Special Meeting Agenda City of Sacramento Design Commission

3. **P10-042 Oak Park Mixed Use Development** (Noticed on 9/01/10)
Location: 3820 Broadway, District 5, 014-0171-001-0000, 014-0171-017-0000, 014-0171-018-0000, 014-0171-019-0000, 014-0171-020-0000, 014-0171-025-0000
Recommendation: Approve- Item A: Environmental Exemption (Per CEQA 15332); **Item B:** Mixed use development including a 56 unit Senior Housing component and 4,000 square feet of retail, and 42 parking spaces, on a C-1 parcel merger in the Broadway/Stockton Special Planning District and Oak Park Design Review District.
Contact: Matthew Sites, Associate AIA, LEED AP, Design Review Staff, 916-808-7646; Luis Sanchez, AIA, LEED AP, Senior Architect
- Action: Moved, seconded, and carried (Sehnert/Fong; 4:0:3, Absent- Miyamoto, Chandler, and Nybo) to continue the item to a Special Meeting on October 13, 2010.**

Subject: **3820 Broadway (P10-042)** Located at the southeast corner of Broadway and Martin Luther King Jr, Boulevard, a request to develop a three story 56 unit residential with ground floor retail on 1.2+/- acres in the Broadway/Stockton and Oak Park Special Planning District (C-1-SPD) zone.

After the he

ENLARGED ELEVATIONS
29 SEPTEMBER 2010

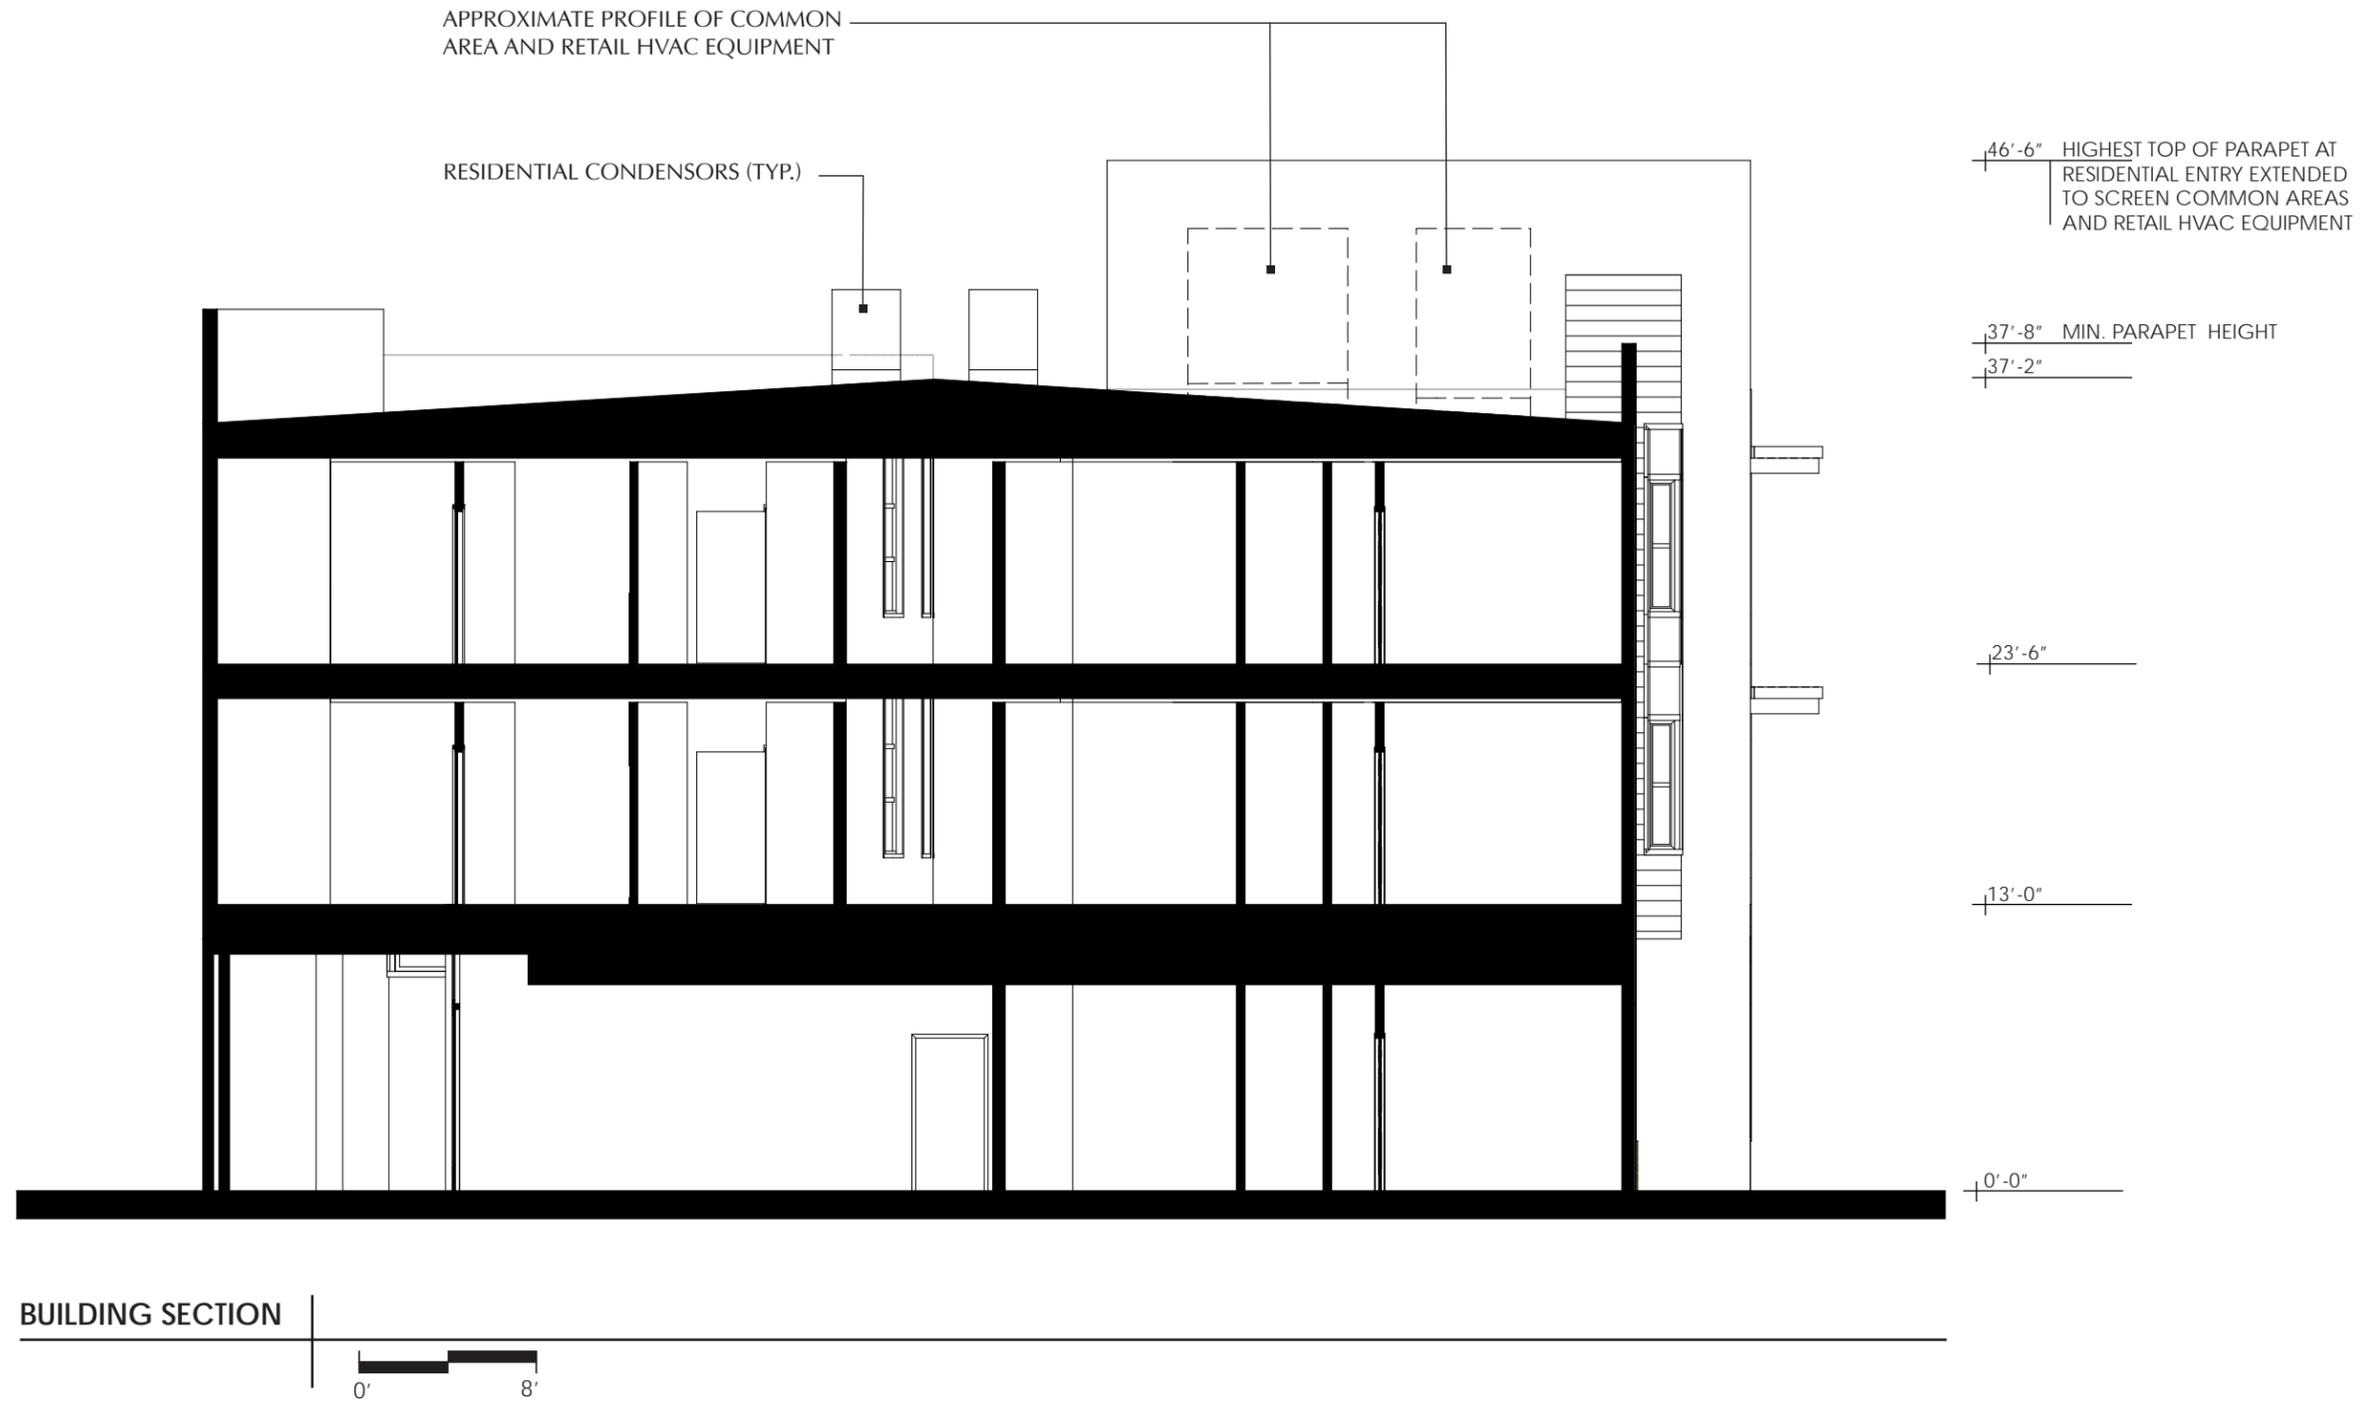
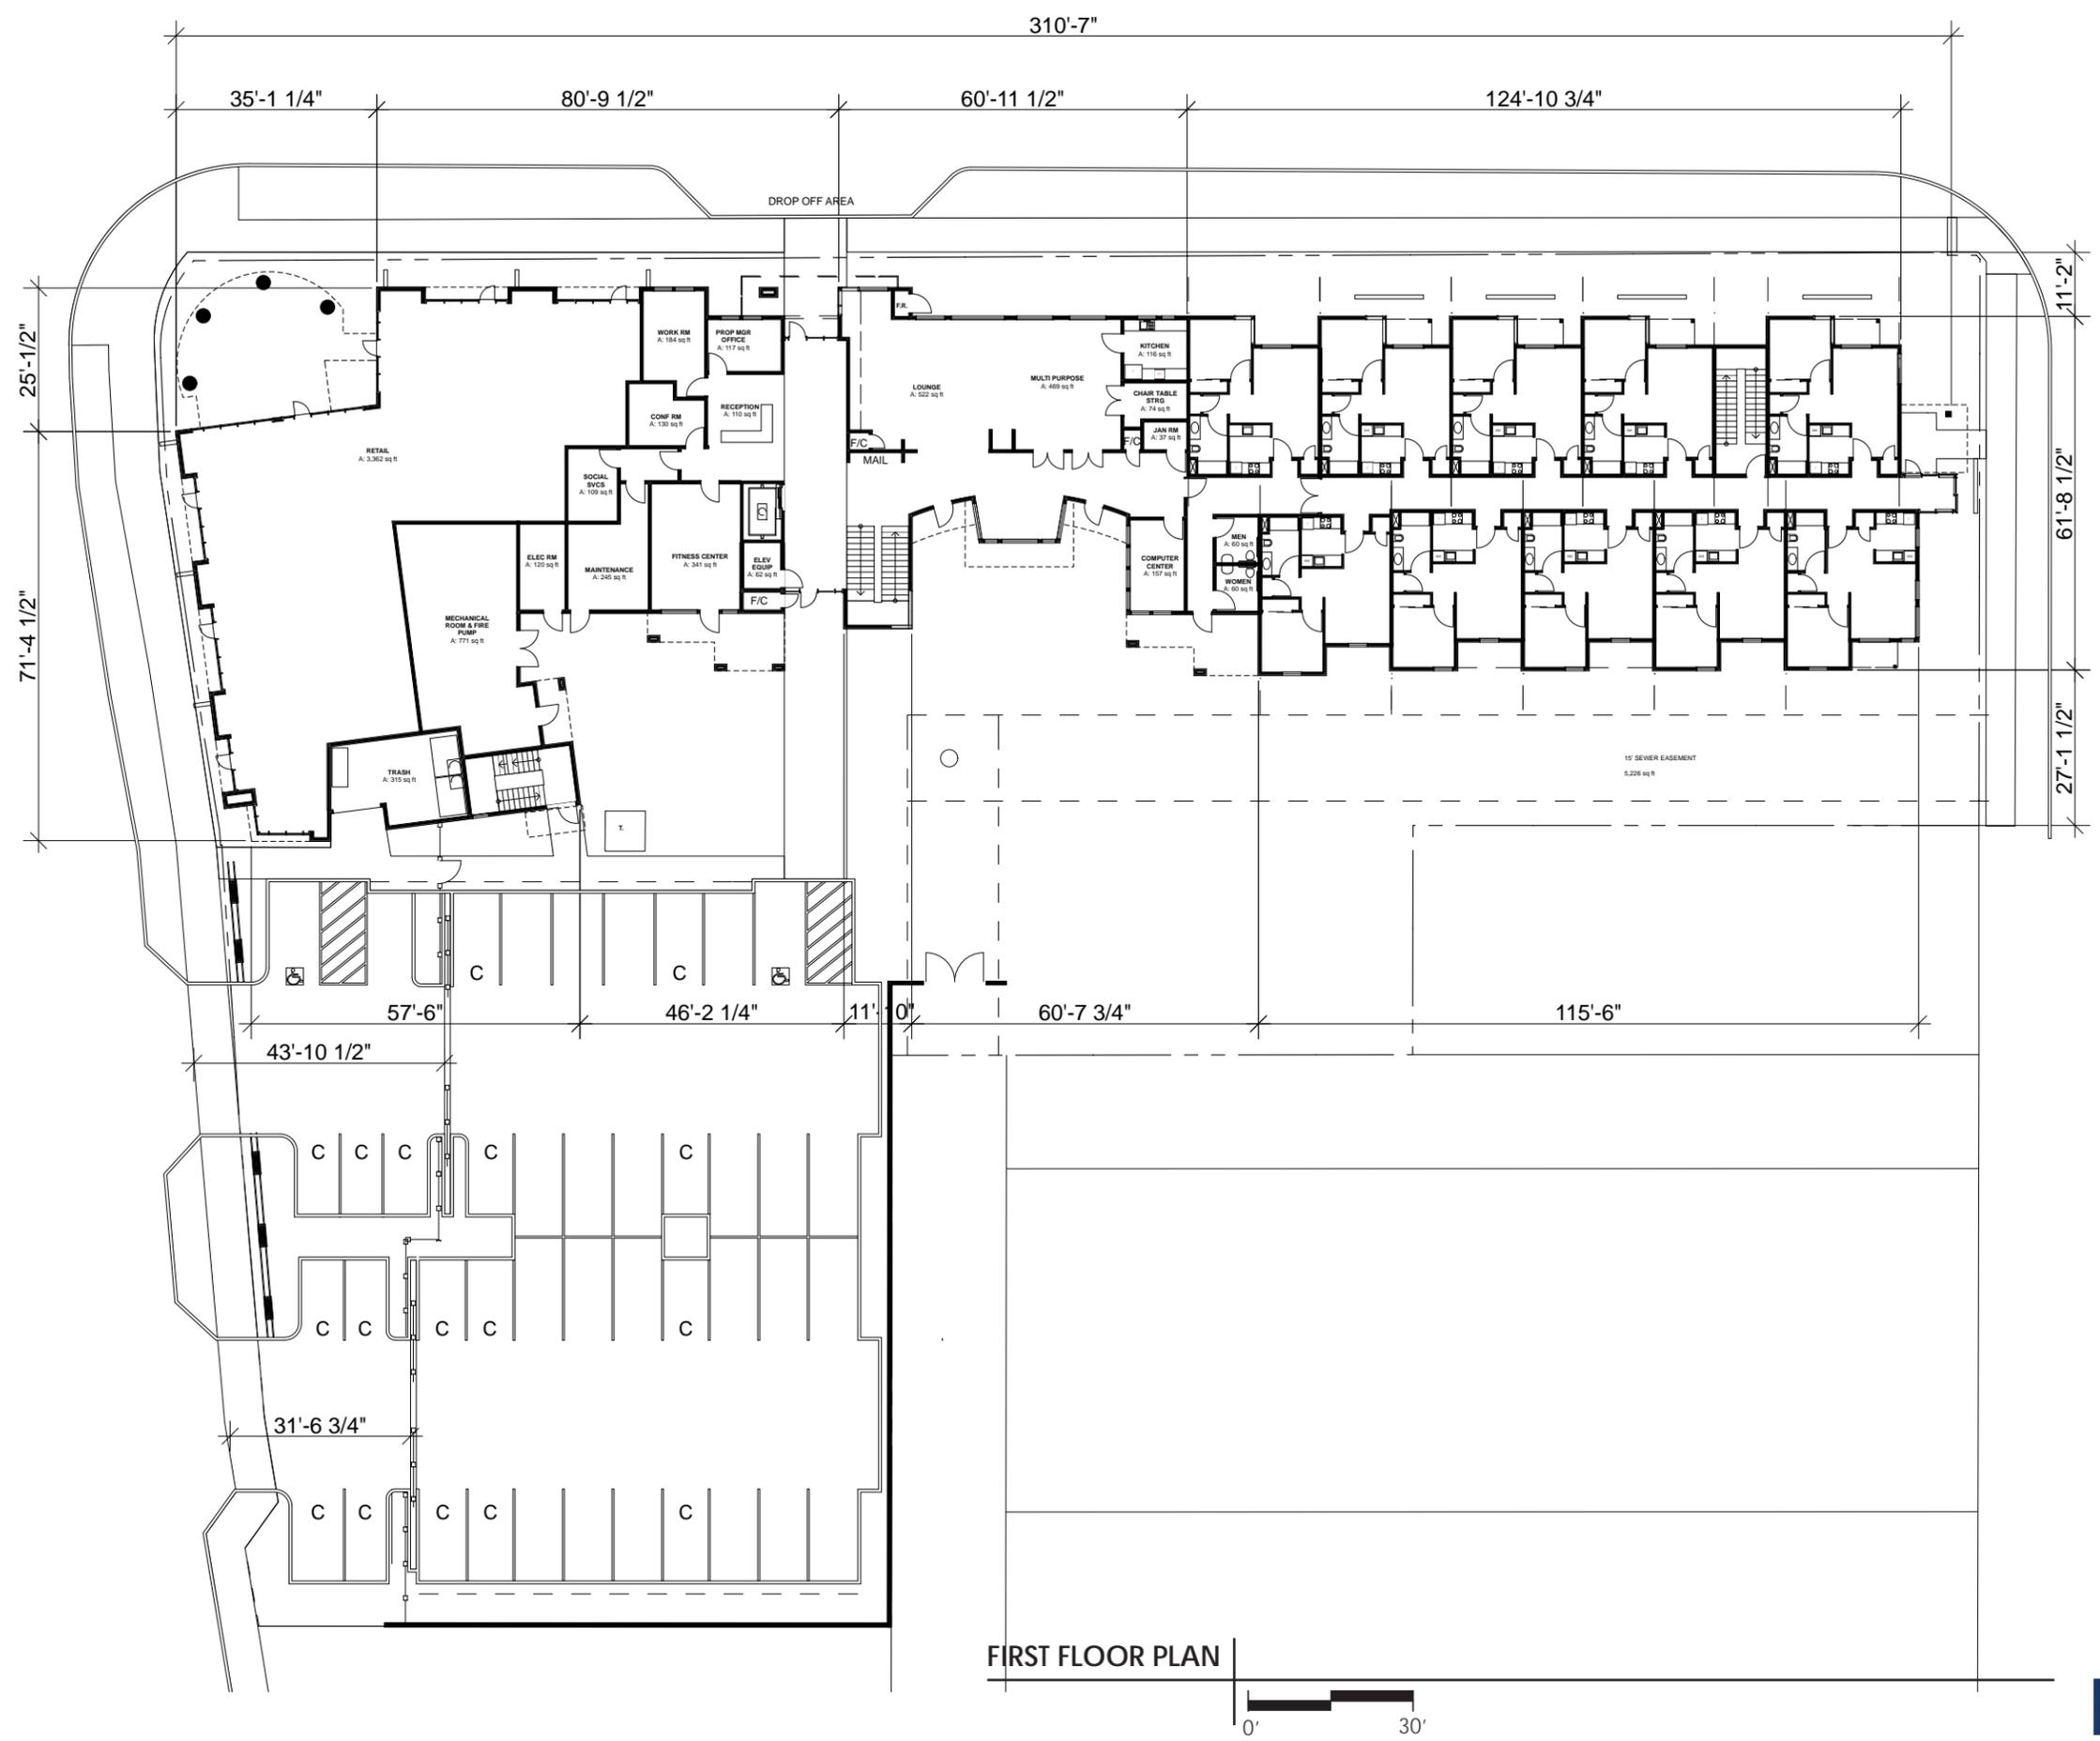
10. Due to the fast turnaround time, the corner element issues have not been resolved, **but staff has been working with the design team and owner since the previous Review and Comment Hearing and feels that corner element has evolved past the previous issues with some exceptions. SHRA, the Design Team and City Staff have agreed that the two story height of the loggia is appropriate for the site conditions and program requirements, but the final articulation and integration of the column design, loggia soffit, and third story cornice are critical to a successful corner. Staff is supportive of the Option A column design, and the cornice design of Option B. Staff feels that the soffit should be inset and recessed in order to emphasize the column connection and importance of the loggia. The applicant has provided several examples of classically styled loggia, and staff feels that a modern interpretation of the recessed soffit would strengthen the two story loggia volume. Staff recommends that the applicant provide a reflected ceiling plan of the loggia and a thumbnail cross-section of the soffit and column interaction at the hearing. In order to distinguish this corner separately from the US Bank Building on Broadway, Staff recommends further refinement of third floor awning, so as not to appear as a direct interpretation of dentil molding. The awning may benefit from the same awning/sunshade style and materials provided along the Martin Luther King, Jr. façade.** ~~The corner issue includes the use of brick, location and integration of columns, changes to column bases and capitals, and locations and design of bollards. The applicant has provided two options for the column base design and staff recommends Option B which includes a lower round base. Applicant should provide revised corner element detail at the hearings.~~

20. The building elevations shall have a consistency of detail and quality as indicated in the report and exhibits.
21. Final configuration of the corner shall be redesigned per direction of the Design Commission at the hearing. **Final plans and configuration shall be provided for review and approval by Design Review staff prior to Building Permit submittal.**

ROOF PLAN

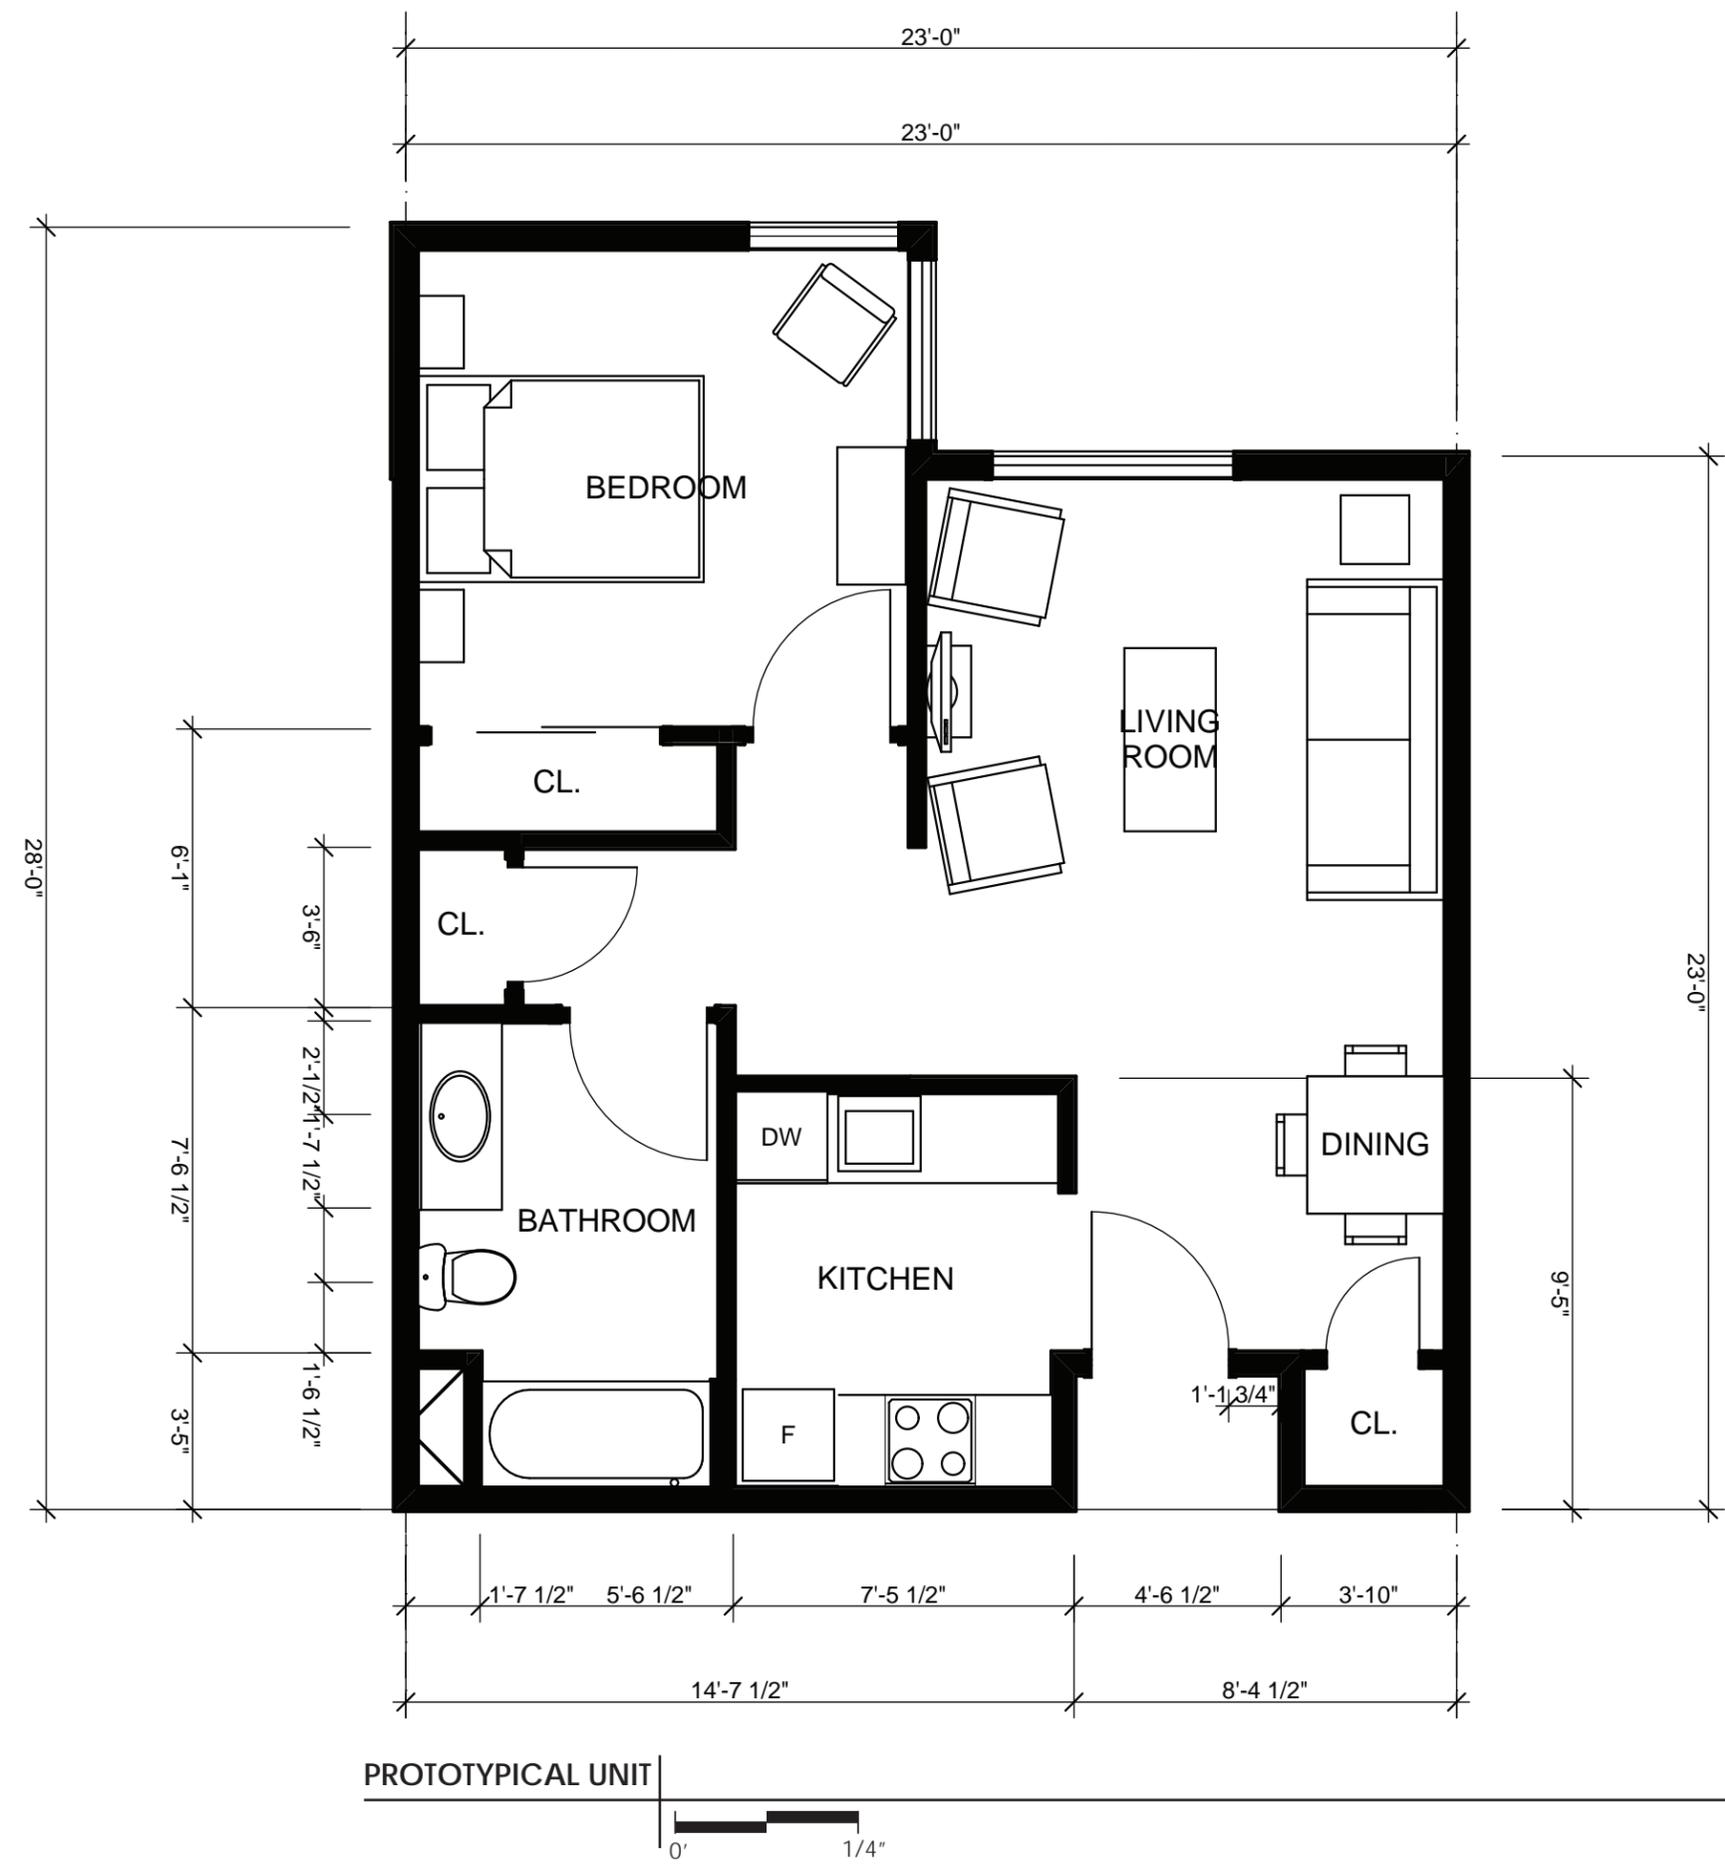
13. The applicant provided staff with a roof plan and cross-section regarding the mechanical system locations and heights. Staff is supportive of the HVAC locations as the small units will have minimal height and hidden behind the parapet, and the larger common space units will be located behind the entry parapet.

25. The common residential area HVAC system shall be incorporated within the main entry parapet and the residential unit HVAC systems shall be located behind the parapet wall, so as not to be visible from any street views. **Final roof plan with mechanical equipment locations, a section through the HVAC unit and building, and cut sheets shall be reviewed and approved by Design Review staff prior to Building Permit submittal.**
